**Economic Commission for Europe****Inland Transport Committee****World Forum for Harmonization of Vehicle Regulations****Working Party on Passive Safety****Seventieth session**

**UN Regulation No. 136 (Electric vehicle L)****Proposal for the 01 series of amendments to UN Regulation No. 136 (specific requirements for the electric power train of vehicles of category L)****Submitted by the expert from the International Motorcycle Manufacturers Association \***

Figure 1

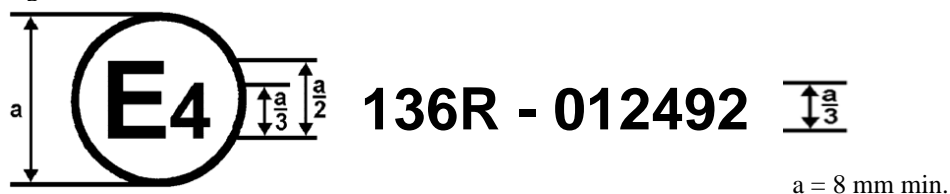
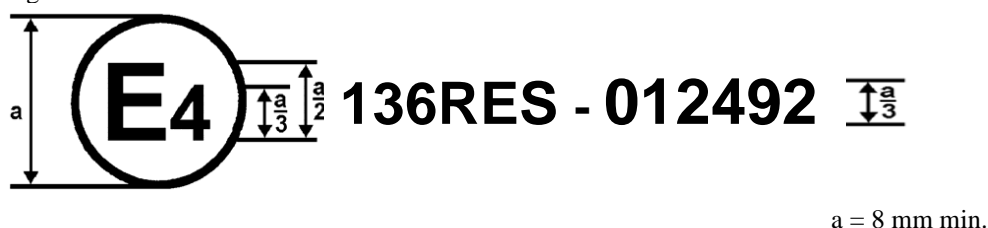
The approval mark in Figure 1 affixed to a vehicle shows that the road vehicle type concerned has been approved in the Netherlands (E 4), pursuant to Regulation No. 136, and under the approval number 012492. The first two digits of the approval number indicate that the approval was granted in accordance with the requirements of UN Regulation No. 136 as amended by the 01 series of amendments.

The approval mark in Figure 2 affixed to a REESS shows that the REESS type ("ES") concerned has been approved in the Netherlands (E 4), pursuant to Regulation No. 136, and under the approval number 012492. The first two digits of the approval number indicate that the approval was granted in accordance with the requirements of UN Regulation No. 136 **as amended by the 01 series of amendments**.

**Figure 1**  
Example of Test Method using DC Power Supply

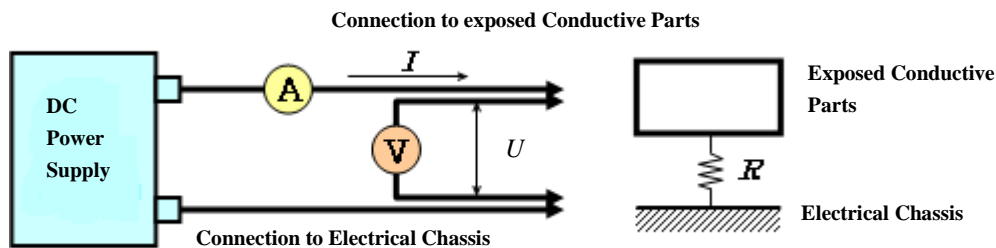
2. Test method using DC power supply, voltmeter and ammeter.

Example of the test method using DC power supply, voltmeter and ammeter is shown below.

**Figure 1**  
**Standard Nozzle for the Test**

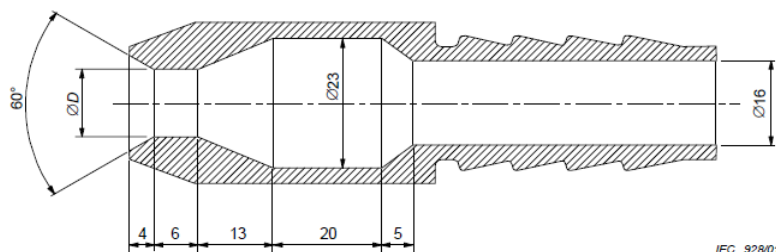
- 2.2. For electrical components, externally attached (e.g. in engine compartment), open underneath, both exposed or protected locations, the testing authority shall verify, with a view to confirming the compliance, whether the test is conducted by spraying the high-voltage component or system from all practicable directions with a stream of water from a standard test nozzle as shown in Figure 1. The following parameters are observed during the test in particular:

- (d) Test duration per m<sup>2</sup> of surface area of the tested high-voltage component or system: 1 min;
    - (e) Minimum test duration: 3 min;

- (f) Distance from nozzle to tested high-voltage component or system surface: approximately 3 m (this distance may be reduced, if necessary to ensure proper wetting when spraying upwards).

$D$  is 6.3 mm as specified in (a) above.
